**BLUE BIRD**

## **SECOND FINAL NOTICE**

**SUBJECT: RECALL R14XE  
STEERING SHAFT CLAMP MAY CONTACT RUBBER  
CLOSEOUT BOOT**

**NHTSA RECALL NO. 14V-309 SCHOOL BUS  
NHTSA RECALL NO. 14V-306 NON-SCHOOL BUS**

Fig. 1

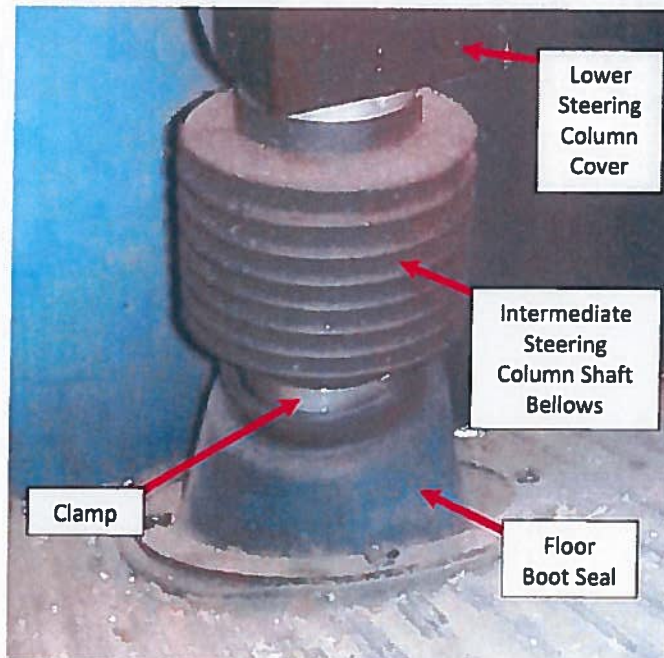
Clamp on intermediate steering column shaft bellows may contact steering shaft floor boot seal and tear floor boot seal and bind steering shaft causing increased steering effort.

1. Park bus on a level surface, apply parking brake, turn off ignition, remove ignition key and chock rear wheels.
2. Inspect steering shaft floor boot seal for wear or damage and slit is toward front of bus.
3. If damaged or worn, complete section **Steering Shaft Floor Boot Seal Replacement** before continuing.
4. After completing section **Steering Shaft Floor Boot Seal Replacement** or if there is no damage or wear to the floor boot seal, complete section **Intermediate Steering Column Shaft Bellows Adjustment**.

Remove clamp and raise bellows on intermediate steering shaft beyond interference and secure with narrow worm gear clamp.

## Intermediate Steering Shaft Assembly Exploded View

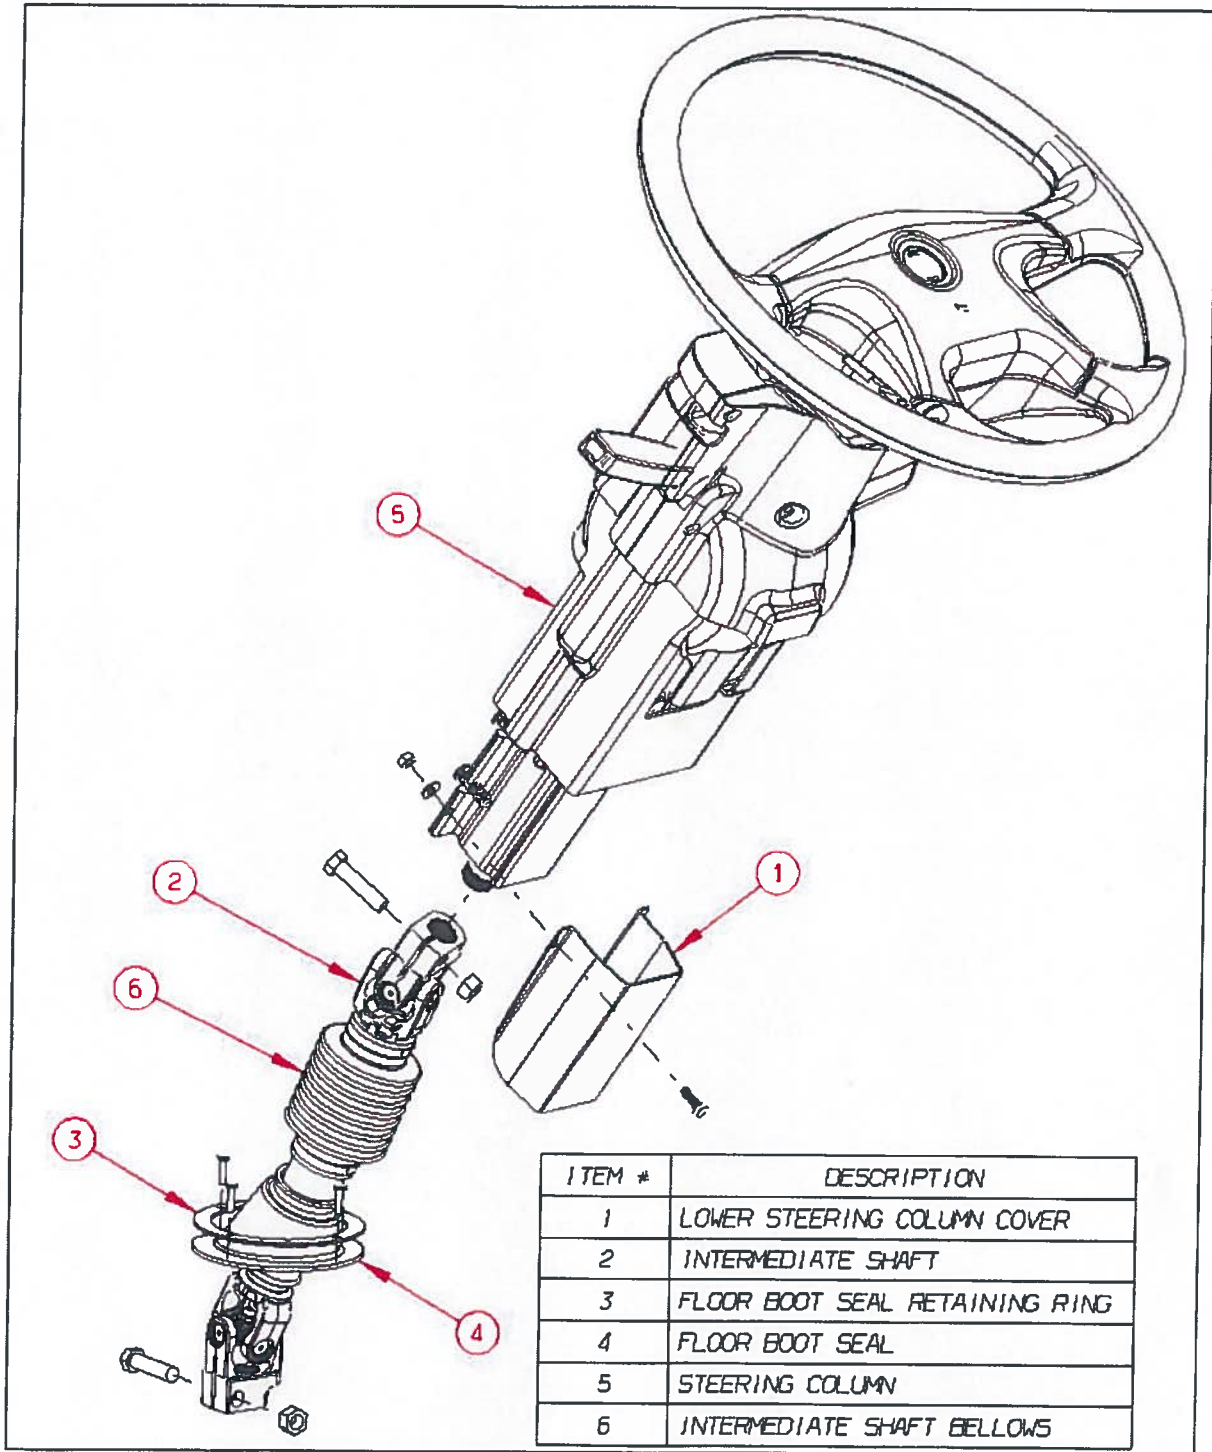
### Steering Shaft Floor Boot Seal Replacement (Use exploded view on page 2 for reference)

Fig. 2

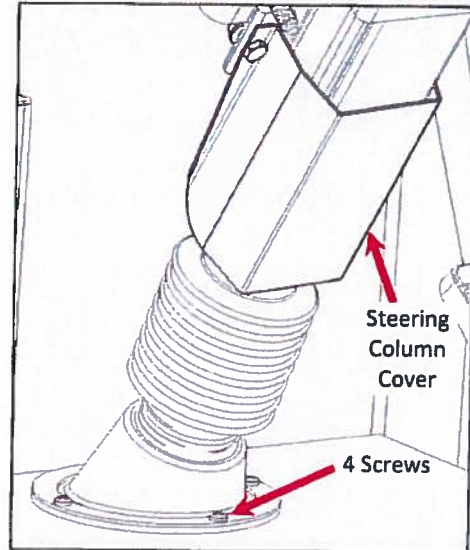
1. Remove lower steering column cover and discard fasteners. (Fig. 2)
2. Remove four screws from steering shaft floor boot seal retaining ring.  
Boot seal and retaining ring should be loose from floor. Keep screws for re-use. (Fig. 2)
3. Remove pinch bolt and nut from upper portion of intermediate shaft. Discard bolt and nut. (Fig. 3)
4. Remove pinch bolt and nut from lower portion of intermediate shaft. Discard bolt and nut. (Fig. 3)
5. Compress intermediate shaft together while removing it from splines on steering column and transfer box.
6. Pull intermediate shaft up through hole in floor.
7. Cut off bellows clamp on lower section of intermediate shaft. (See Fig. 3)

Fig. 4

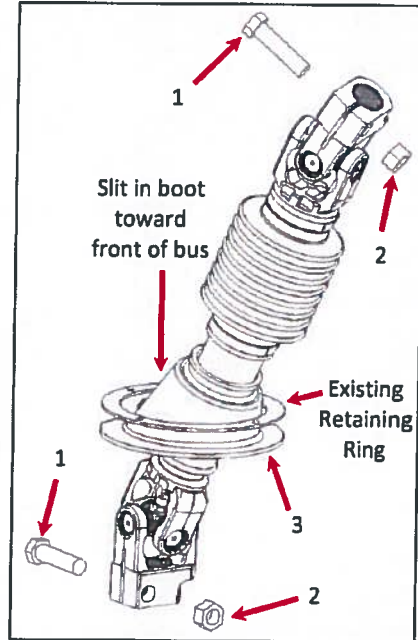
8. Replace floor boot seal on intermediate steering shaft and re-install intermediate shaft using new fasteners. (See Fig. 4)
  - a. Torque pinch bolts 36-43 FT-LBS.
9. Re-install floor boot seal with retaining ring with four screws. Slit in floor boot seal should be oriented toward front of bus. (See Fig. 5)
10. Install lower steering column cover with new fasteners. (Fig. 6)
  - a. Torque nuts to 37-41 FT-LBS.

Fig. 7

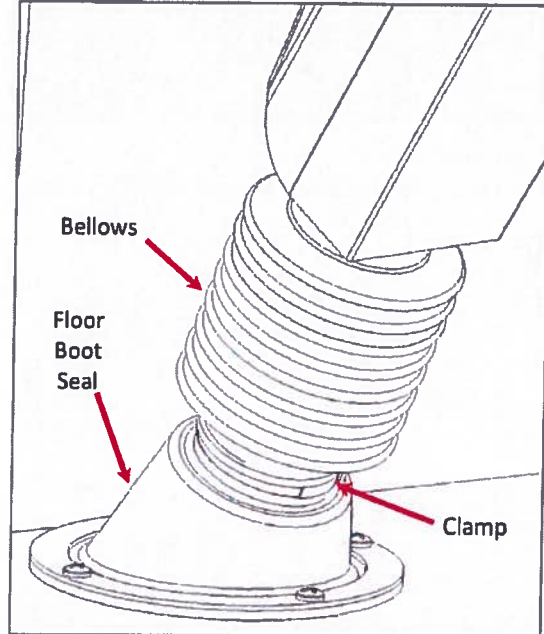
1. Cut off bellows clamp on lower section of intermediate shaft if present. (Fig. 7)
2. Push bellows up until it is no long in contact with steering shaft floor seal boot.
  - a. Minimum 0.50 inch gap between floor seal boot and bellows.
3. Open new worm gear clamp until it releases then secure it around bellows. (Fig. 8)
  - a. New clamp must ride all the way around in groove on bellows.
  - b. Torque clamp to 10-15 in-lb.
4. Inspect the floor boot seal and bellows for minimum 0.50 inch clearance all the way around the intermediate steering column shaft.
5. Recall is complete. Place bus back into service.
